STEFFEN ROBERTSON AND KIRSTEN (B.C.) INC. Consulting Engineers

Project Number 60619

RE: OCTOBER 23, 1991 SITE VISIT

Plate 1

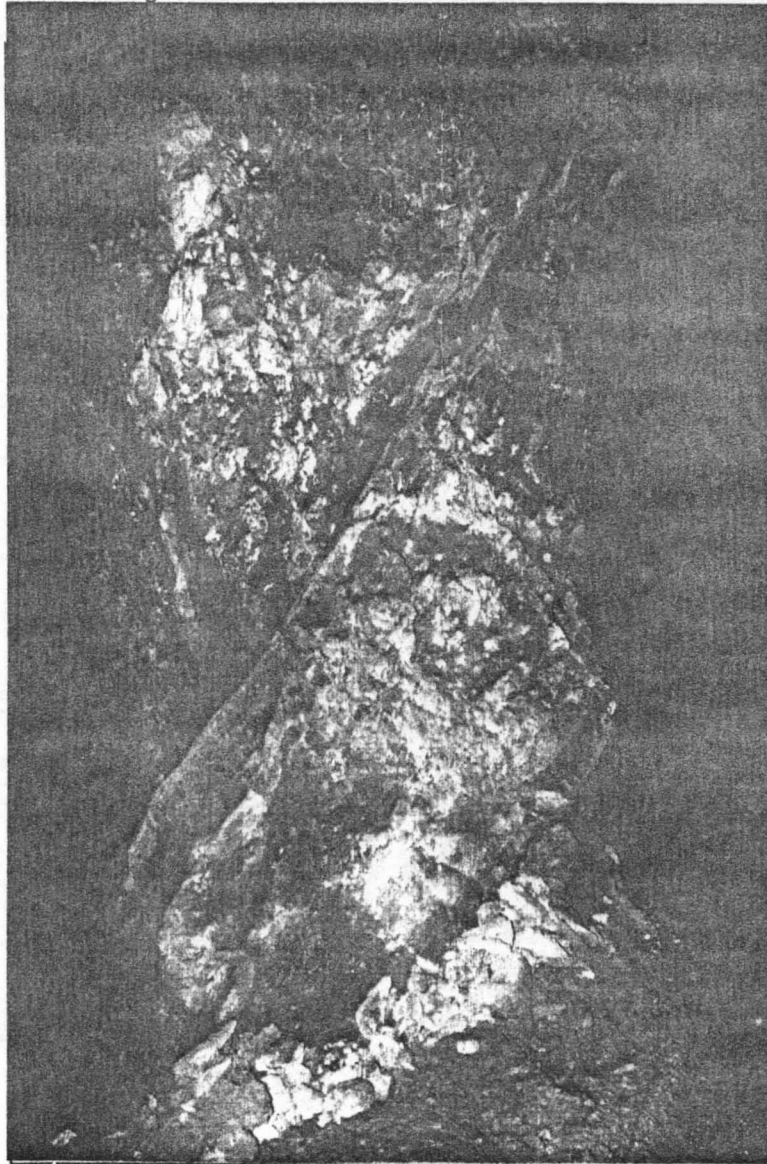
An example of what should be noted during pillar inspection is indicated in Plates 1 and 2. Both photographs were taken during the current site visit. Plate 1 is a photograph of a pillar in the North B ramp. Several items may be noted from examining this picture:

- diagonal fault through pillar. Pillar is likely only supporting itself
- lack of bolting. Two split-sets are visible in the pillar, with both being ineffective.
- lack of monitoring. No paintlines or other methods to indicate possibly dangerous pillar movement.
- breasting conducted adjacent to pillar without proper pillar support or pillar monitoring.

Plate 2

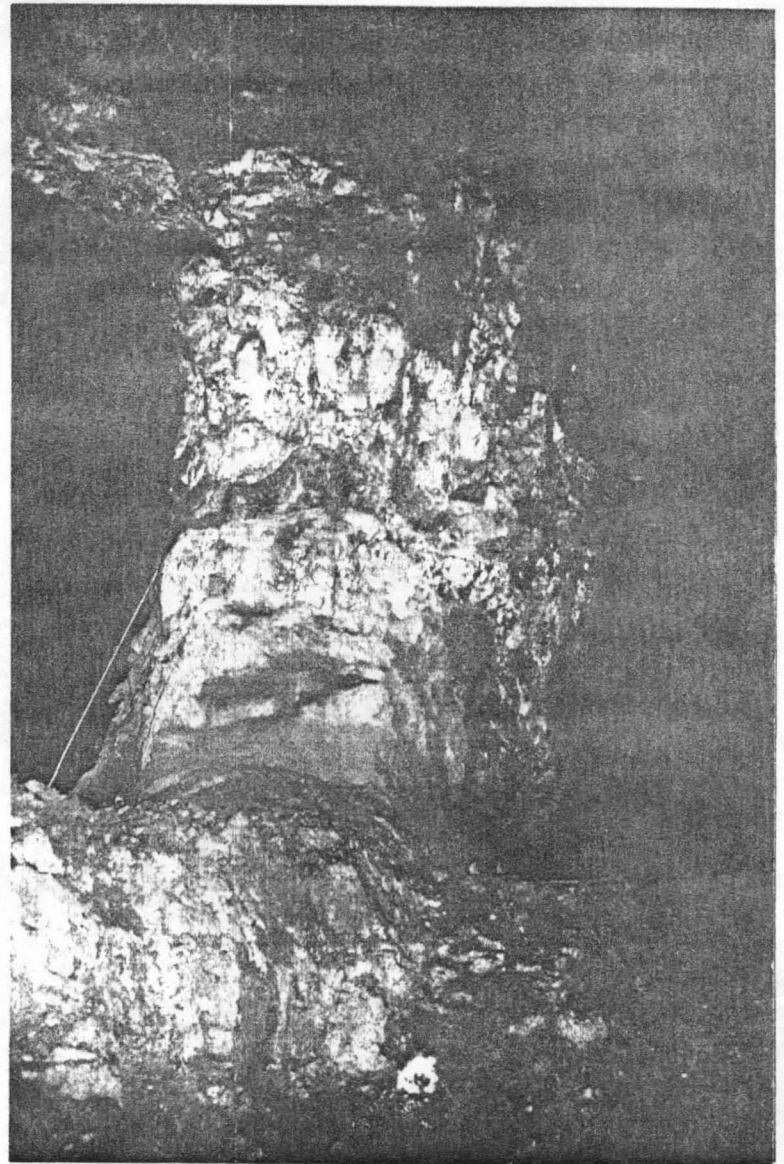
Plate 2 shows the pillar adjacent to that shown in Plate 1. Note that:

- pillar is curved in the vertical plane. Load line falls near one edge, decreasing stability.
- no pillar or back monitoring
- no pillar support
- active breast face (note trunklines) adjacent to pillar which cannot be scaled (too high) and is not monitored for stability.
